Docket No. 50-409  
LS05-82-08-067

SUBJECT: SEP SAFETY TOPIC II-4.D, SLOPE STABILITY  
LACROSSE BOILING WATER REACTOR

Systematic Evaluation Program Topic Assessment  
Topic: II-4.D - Slope Stability  
Plant Name: LaCrosse Boiling Water Reactor Plant (LACBWR)  
Docket Number: 50-409  
TAC Number: 41280

Figure 2 Soil Test Borings

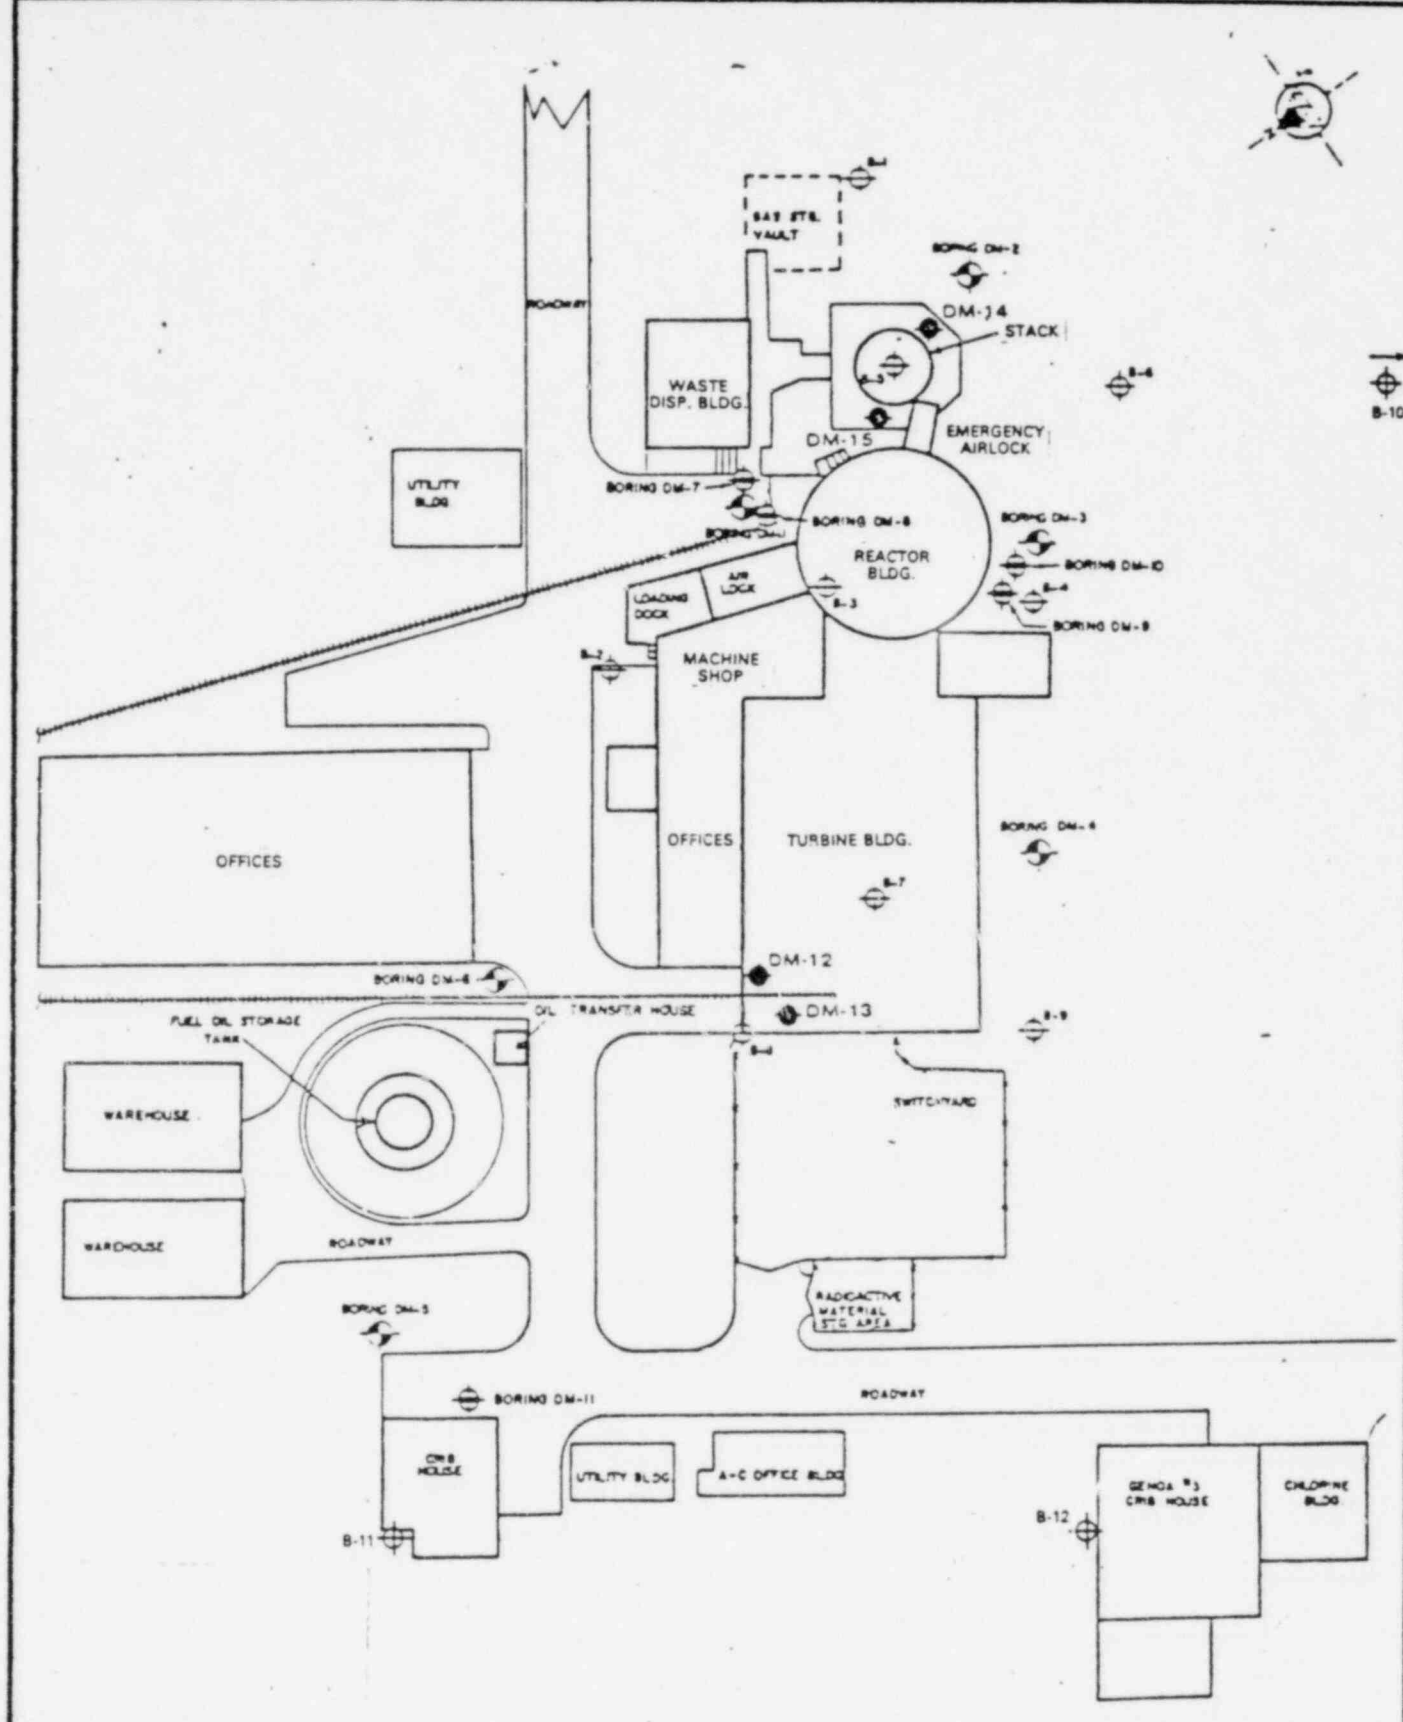
The initial soil investigations at the LaCrosse site were conducted in 1962. Between 1962 and 1980 soil test borings were made at 36 locations in the site vicinity. Of this number, five were associated with subsurface investigations in the power station area, four were associated with the switchyard area, and one was drilled to locate an offsite borrow area for construction fill materials. The remaining 23 were associated with subsurface investigations in the main plant facility area (see Fig. 2). The licensee has presented boring logs depicting the soil conditions encountered in these investigations (Ref. 1, 2, 3, & 4). Field investigation effort included standard penetration tests (SPT) and split-barrel sampling in accordance with ASTM D-1586-67 procedures. Relatively undisturbed samples were also obtained at several locations in thin walled tubes using an Osterberg piston sampler. Laboratory testing of soil samples was accomplished to determine index properties and to establish soil strength parameters. Testing included specific gravity determinations in accordance with ASTM D-854-58, particle size analysis testing in accordance with ASTM D-422-63, relative density determinations in accordance with ASTM D-2049-69 and cyclic triaxial testing in accordance with the procedures of NUREG-0031 (Ref. 5).

Figure 3 East Bank River Slope.

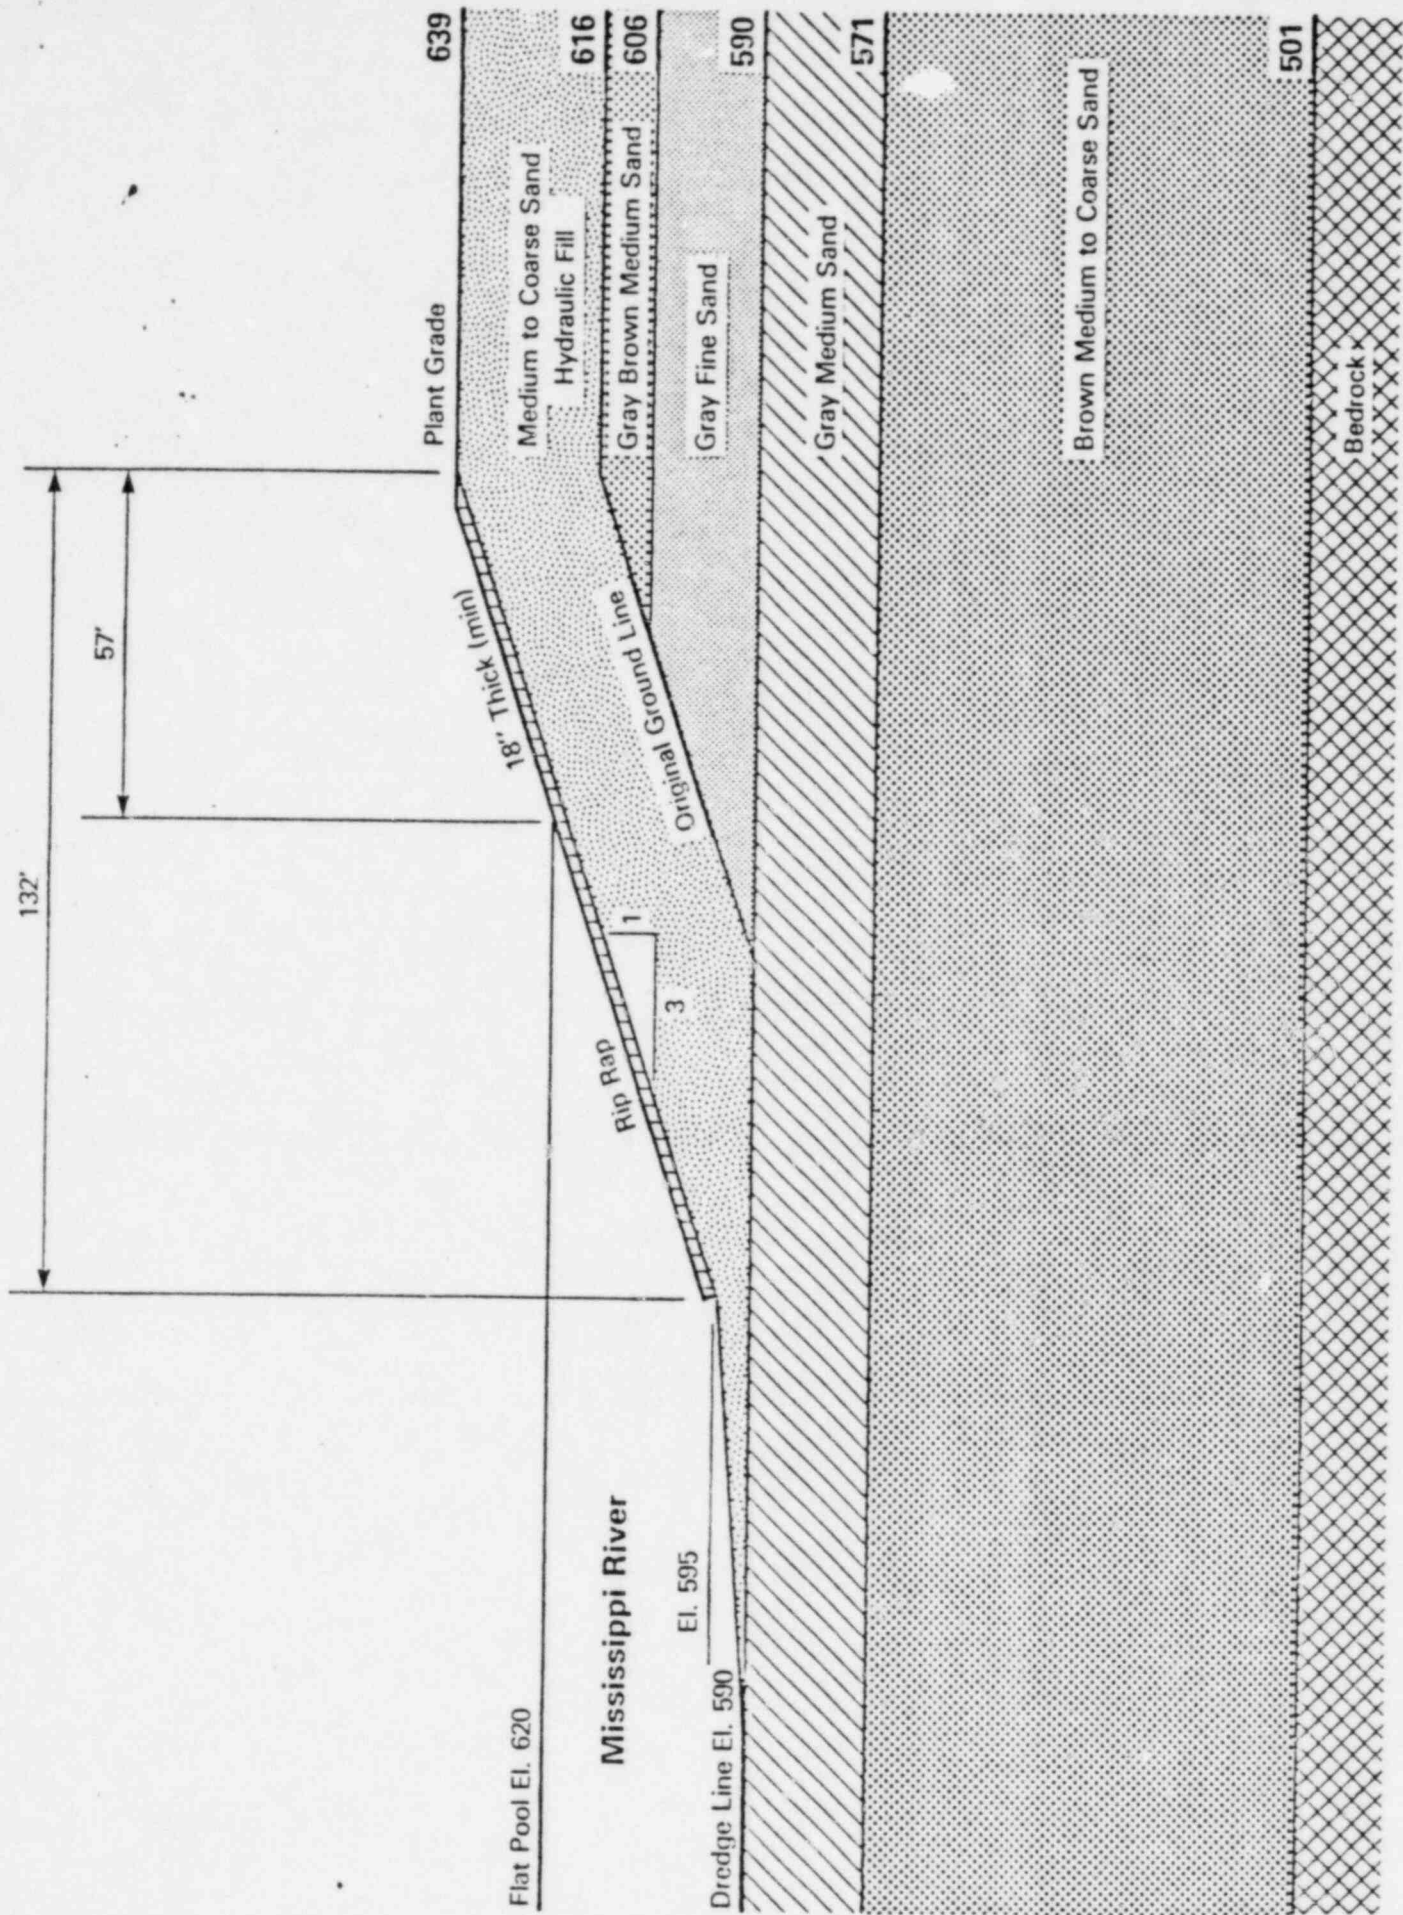
Review of available on and off site topographic data indicates there are no on-site slopes whose failure could cause radiological consequences adversely affecting the public health and safety (Reference 11). One offsite slope, the east bank of the Mississippi River adjacent to the plant cribhouse site was identified from topographic data and evaluated for safety in conjunction with this topic. A generalized typical section for this slope was developed from subsurface data and design features contained in References 2, 11 and 12 and is presented in Figure 3.

The staff has performed a stability analysis of this slope using conservative soil strength parameters developed from the results of the site subsurface investigation reported by the licensee in Reference 2 and using the procedures presented in References 13, 14 and 15. In the analysis an angle of internal friction  $\phi$  of  $27^\circ$  was assigned each soil layer and the slope stabilizing influence of the slope protection riprap material was conservatively ignored. Results of the analysis indicates the factor of safety against failure under static loading conditions is greater than 1.5. Based upon the criteria contained in Reference 16 the staff concludes that an adequate margin of safety exists under static loading conditions.

Due to the fact that the cribhouse and the associated water intake and discharge piping are the only plant structures in the vicinity which will potentially be affected by a postulated failure of the east river bank slope, and these structures are not designated as seismic Category I structures, a dynamic (pseudostatic) slope stability analysis is not appropriate and was not performed.
